## PLANNING APPLICATIONS COMMITTEE

23/P2123

**Address/Site:** Outside 13 Station Buildings, Coombe Lane, Raynes Park

**Proposal:** ADVERTISEMENT CONSENT FOR THE PROPOSED INSTALLATION OF ADVERTISED COMMUNICATION HUB UNIT WITH DEFIBRILLATOR.

## SITE PLAN AND IMAGES

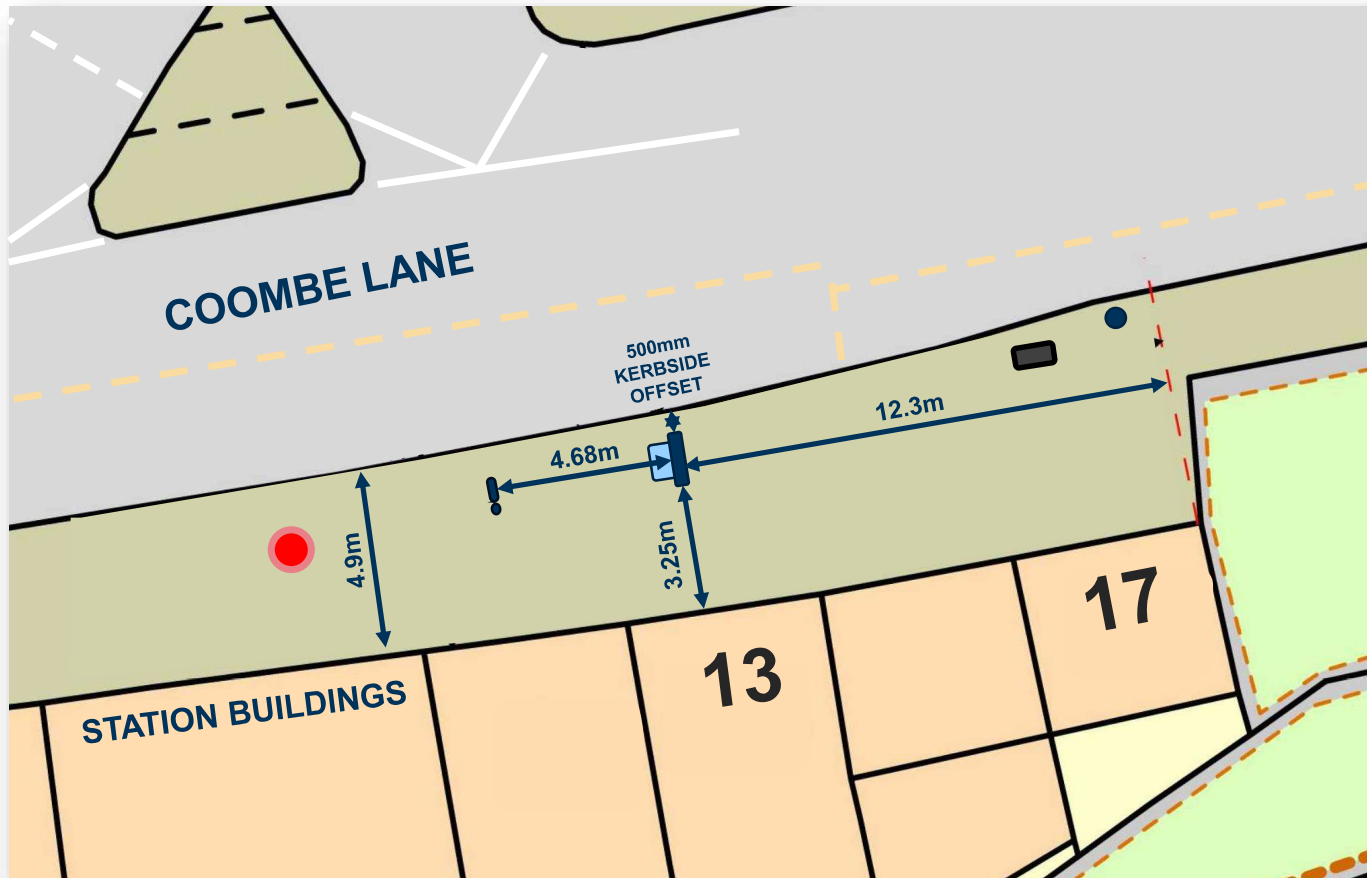
The communication unit is shown on the submitted drawing as being 800mm from the kerbline when it should be 450 from the kerbline to allow sufficient space for pedestrian movement.

7.32 Pedestrian should be able to use the footpath of highways without barriers impeding movement. The Highway Officer commented that the communication hub unit was too far away from the kerblines and that it should be nearer the kerblines to allow for sufficient room to facilitate the free flow of movement of pedestrians and not act as a barrier to this. The Applicant has amended the scheme in line with the Highway Officers' comments. As such, the proposal is acceptable with respect to the use of the highway. The advertisement display would be an LDC screen facing east and the Council's Highways Officer has not raised concern with regards to any impact on users of the public highway when displaying digital advertisements. The proposal is therefore considered to be acceptable in regards to transport and highway safety and would comply with Policies CS18 and CS20.

Revised comments following receipt of amended plans:  
Proposal now acceptable.

7.24 The proposed unit has been moved closer to the pavement edge upon request from the Highways Officer which results in the unit being less of an obstruction to users of the pavement. It is therefore considered the advertisement panel would not have an undue detrimental impact on the character and appearance of the pavement or wider street scene and is compliant with Policies DM D5 and DM D2.
